ST. PETERSBURG CITY COUNCIL

SUBJECT: A resolution accepting Addendum No. 4 — Municipal North Yacht Basin Bulkhead Replacement in an amount not to exceed \$2,964,769 submitted by Skanska USA Building, Inc. ("Skanska") to the Guaranteed Maximum Price ("GMP") proposal dated April 3, 2018 for the construction of a new North Yacht Basin Seawall adjacent to the new St. Pete PierTM; providing that the total GMP for the Pier Approach Project shall not exceed \$19,847,966; authorizing the Mayor or his designee to execute the Sixth Amendment to the Construction Manager at Risk Agreement with a GMP between the City of St. Petersburg, Florida, and Skanska dated January 10, 2017, as amended, to incorporate Addendum No. 4 to the GMP proposal into such agreement, as amended; authorizing the City Attorney's office to make nonsubstantive changes to the Sixth Amendment; approving a transfer in the amount of \$2,964,769 from the unappropriated balance of the Downtown Redevelopment District Fund (1105) to the General Capital Improvement Fund (3001) to provide funding for new North Yacht Basin Seawall; authorizing a supplemental appropriation in the amount of \$2,964,769 from the increase in the unapp

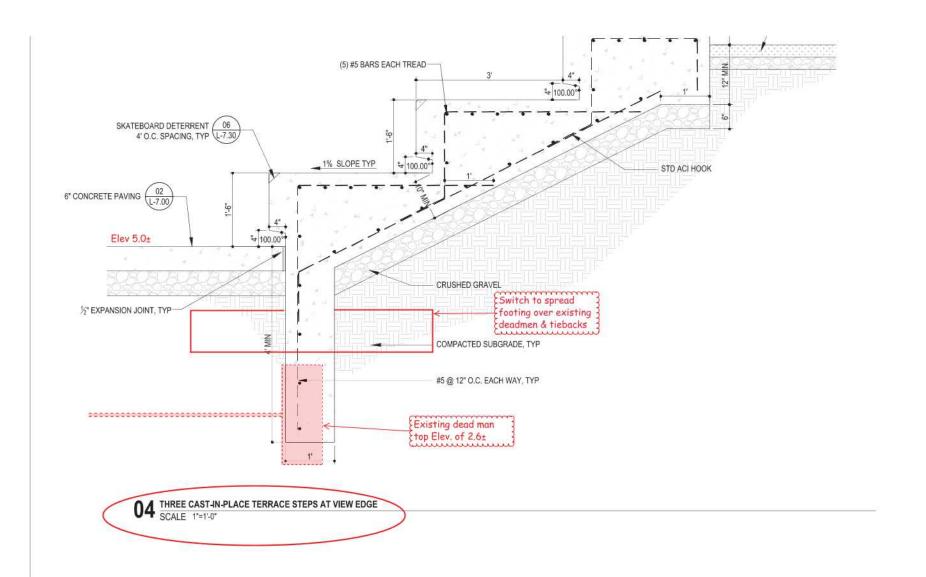
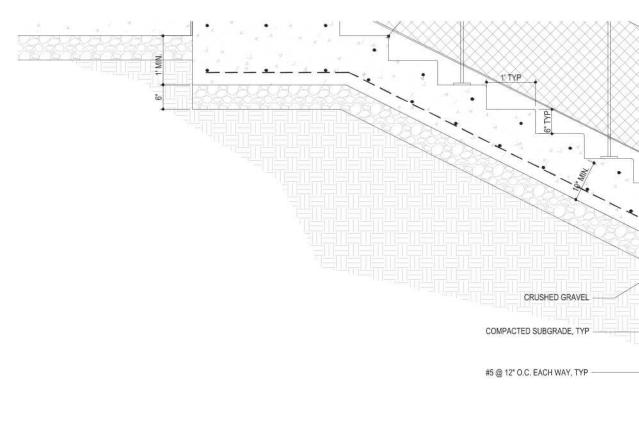
- For the helical anchors, I've attached the cut sheet that we referenced. We don't need to use that exact model. If you have a preference with a particular type or manufacturer, let us know and we can see what works.

- The preliminary length that we've determined is 32 ft measured from the tip of the helical anchor. We assumed an installation angle of 15 degrees down from horizontal, which should put the end of the anchor about 10 ft below the ground surface. Our proposal is based on 32 feet of Anchor and does not include any allowance for additional. If Additional length is required, it will be added cost.

- We've only run preliminary calculations at this point, but they're showing that an anchor at 6'-3" will need a safe working load of 26 kips for the new wall. We haven't run any numbers on the existing wall, but it will be less than what's needed for the new wall. Our proposal is based on a quantity of 64 Helical Anchors to be used in 400' of the wall. If additional anchors are required due to a tighter spacing it will be added cost.

05 CAST-IN-PLACE STAIRS AT VIEW EDGE SCALE 1"=1"-0"

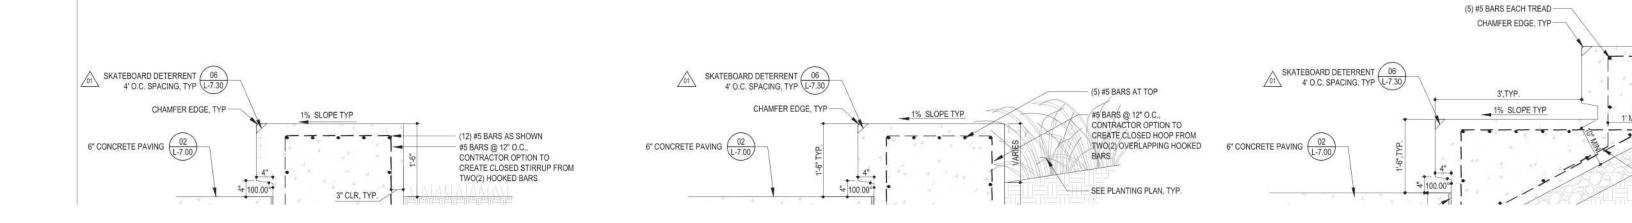
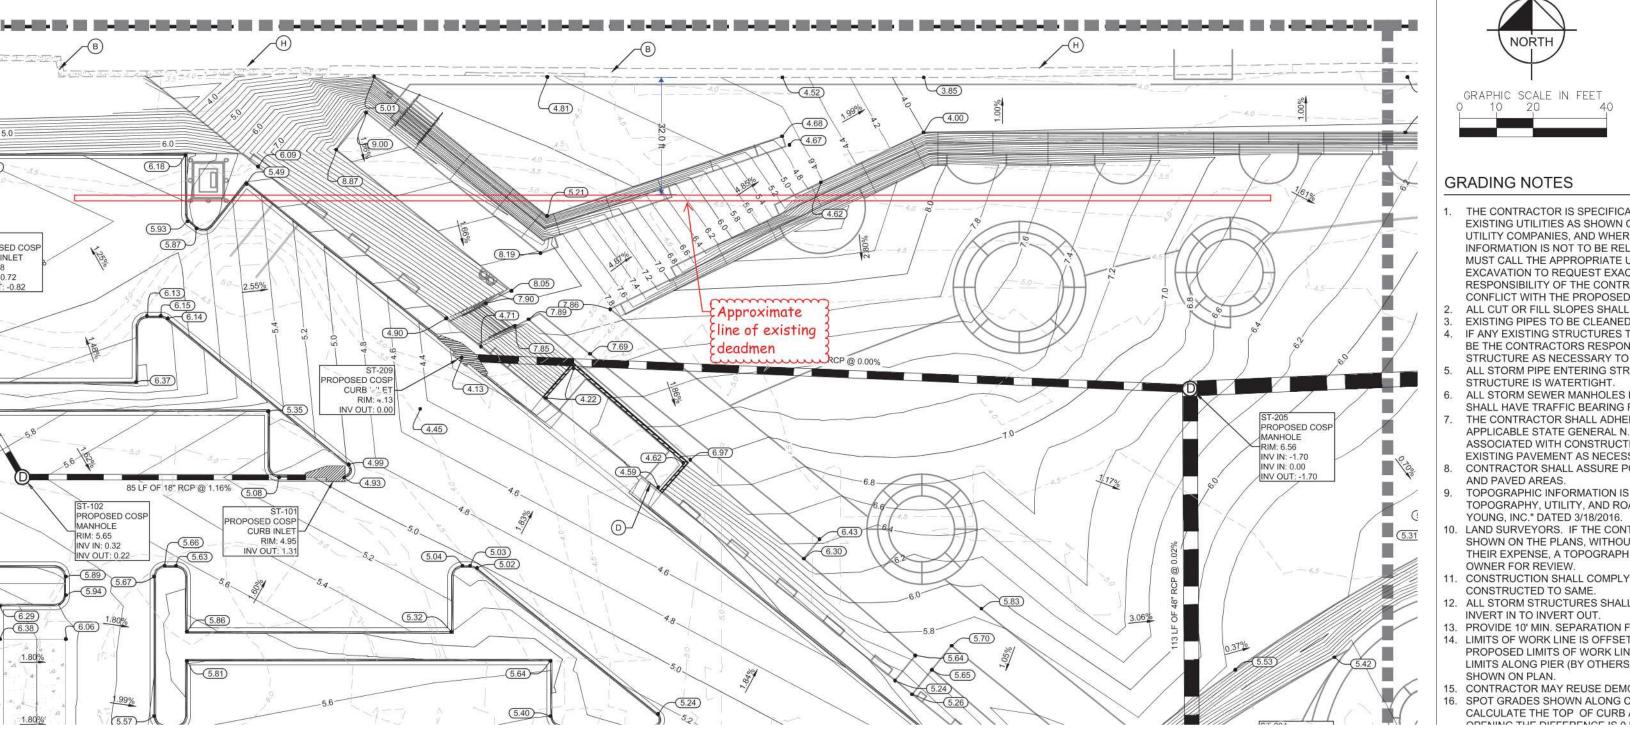
Regarding the conflict with the existing deadmen. Can the upland work be completed without disrupting them? **No** I know that there is a conflict with the foundation of the steps, but are there other issues? Would it be possible to change the vertical foundation of the steps to a spread footing? **No, do not recommend.** If so, this would allow the existing deadmen to stay in place during upland construction and tiebacks could be installed with the sheet pile. I've attached a sketch of my thoughts. Let us know if you think this is viable or not.
